EXPLANATION OF SIGNIFICANT DIFFERENCE

OPERABLE UNITS NUMBER: 01 & 02 OLD UPPER MOUNTAIN ROAD

City of Lockport / Niagara County / Site No. 932112 / July 2022

Prepared by the New York State Department of Environmental Conservation
Division of Environmental Remediation

Figure 3
Wetland Infill and Restoration/Mitigation
Old Upper Mountain Road (932112)
Lockport, New York

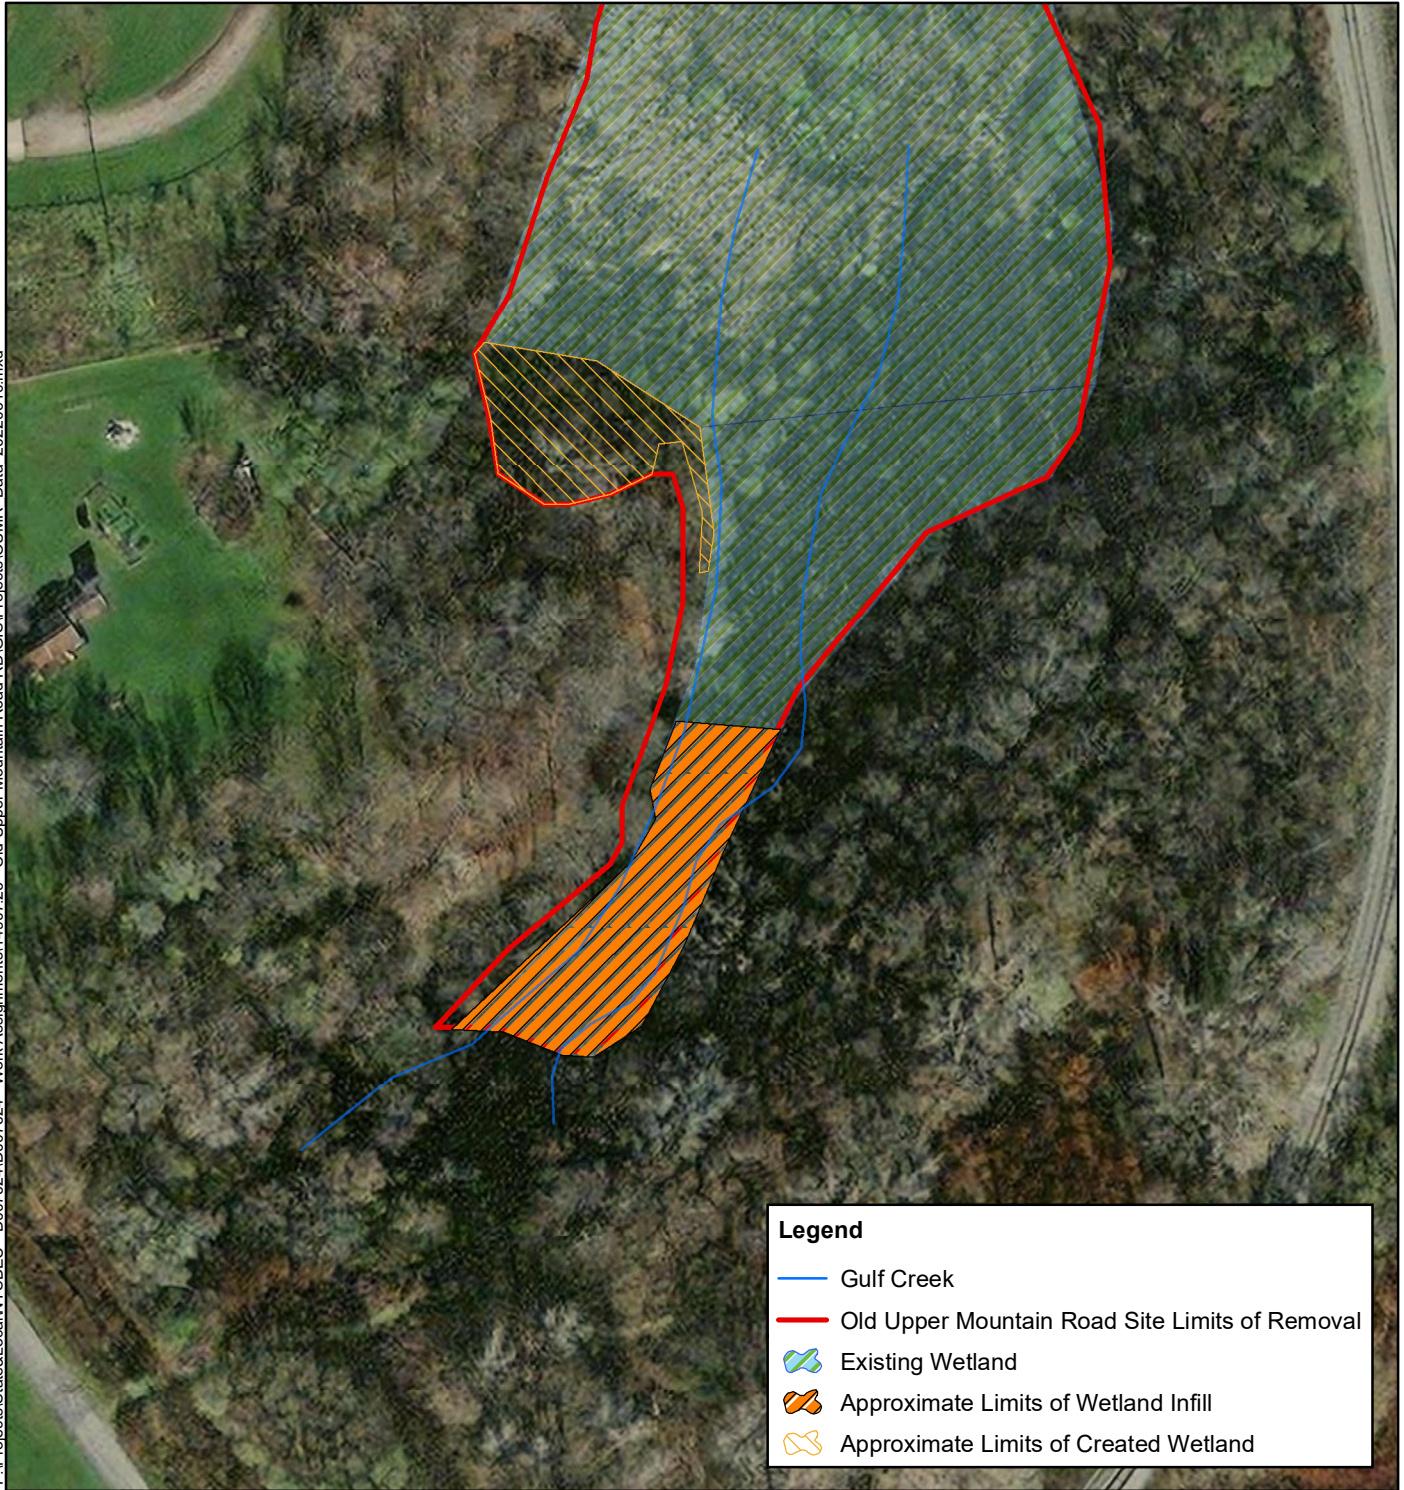
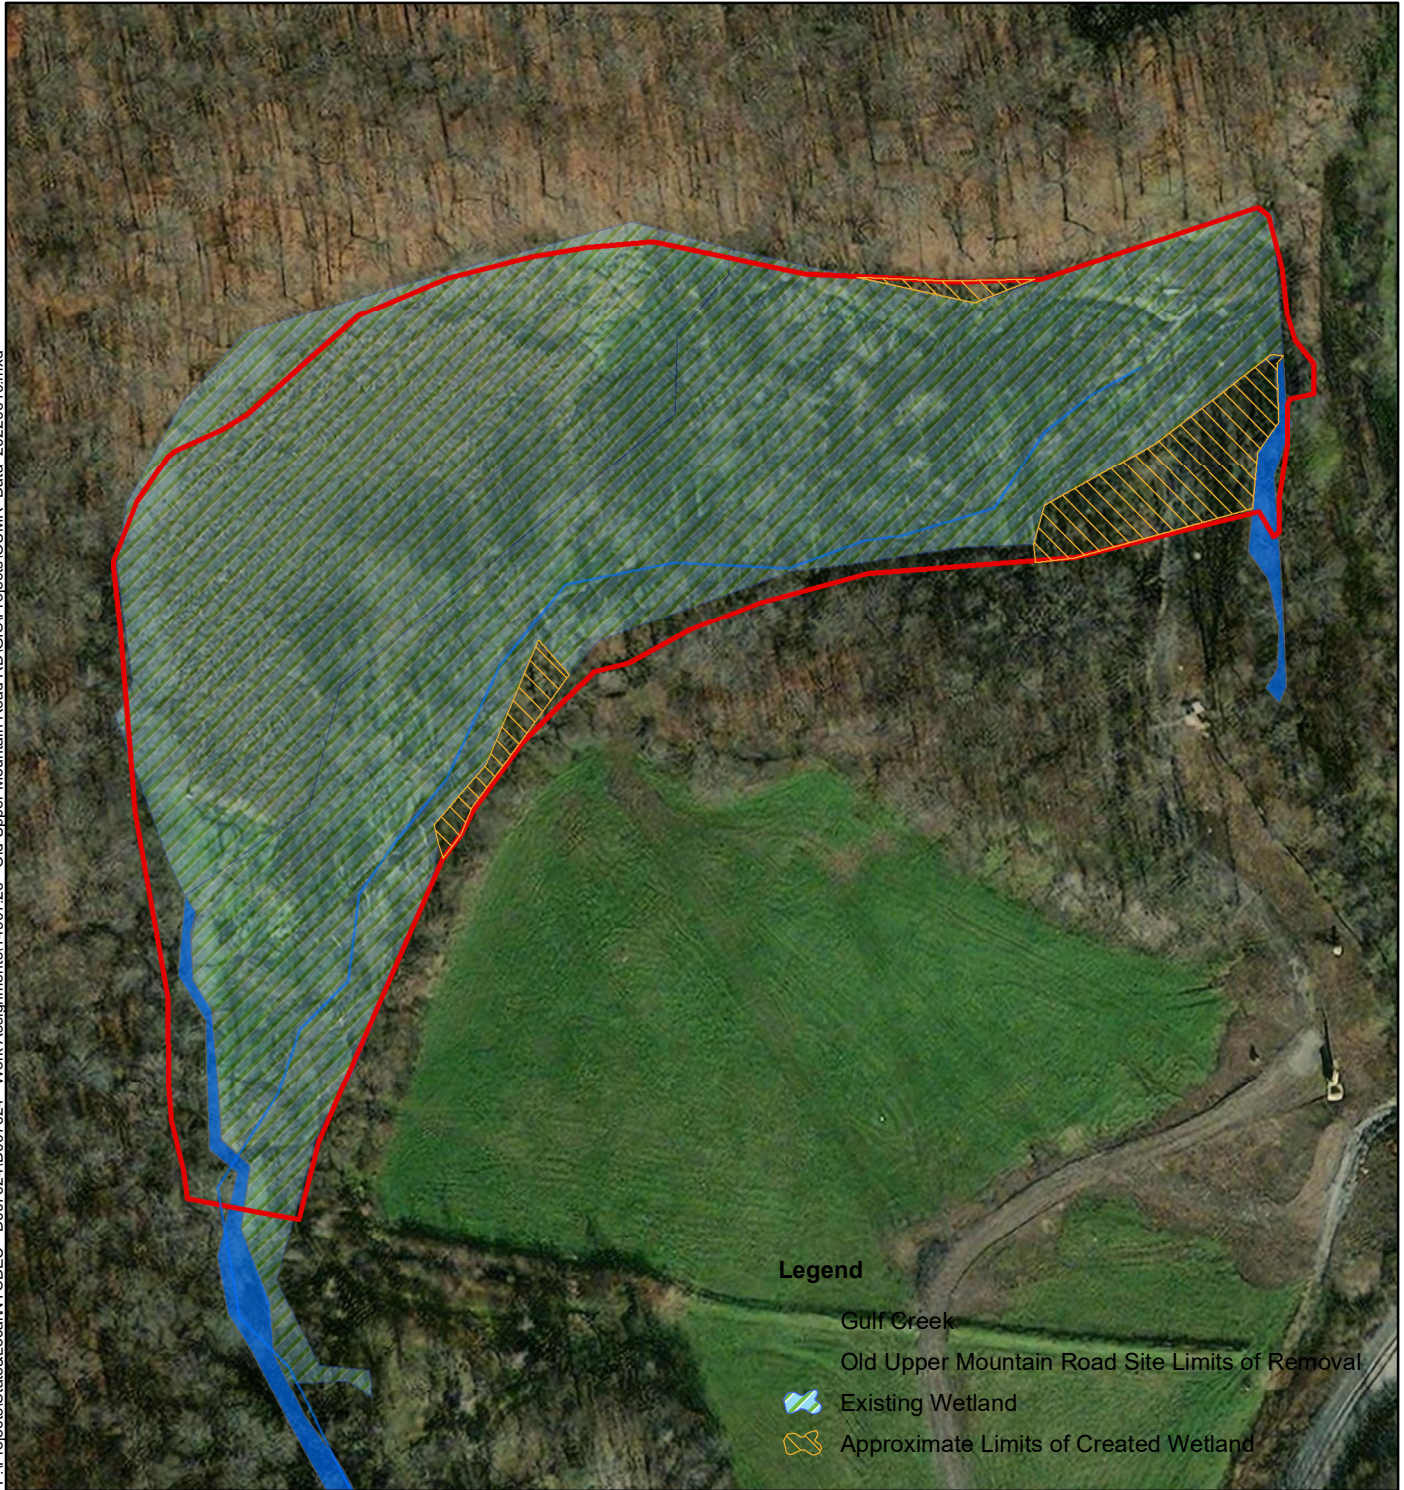
ROD Element 2 of OU01 is modified to reduce the infilling of Gulf Creek to approximately 220 feet or 0.24 acres which was determined to be sufficient to provide space and create the required slopes for stability. This reduction in the infilling and placement of material on the Lockport City Landfill is less than the estimated 1.75 acres (800 feet) prescribed in the ROD. The resulting total loss of wetland habitat due to 1) infilling for the containment cell is 0.24 acres and 2) restoration of a functional stream system (e.g., conversion of wetland to open water) is 1.23 acres. The resulting total loss of open water due to conversion of open water to wetland in restoration of a functional stream system is 0.86 acres. Mitigation for these losses as specified in the previous ROD will be achieved by creating new wetland

acreage and stream channel in OU2 at a 1:1 ratio, as shown in Figure 3. Additionally, ROD element 2 is being modified to include the use of a stone drainage layer (clean aggregate) in lieu of the previously proposed culvert to convey groundwater under fill material. This means of conveyance is being designed to be more efficient and implementable.

Overall, the size and scope of the new containment cell constructed at the Old Upper Mountain Road Site will be reduced through the use of the existing landfill space, approximately 0.24 acres will be infilled for the containment cell. Mitigation will be detailed in a mitigation plan which, at a minimum will replace the area of lost stream/wetland at a 1:1 ratio and be consistent with the requirements of 6 NYCRR Part 608. Modification to the Closed City of Lockport Landfill site is being handled under 6 NYCRR Part 375 requirements for a change of use.
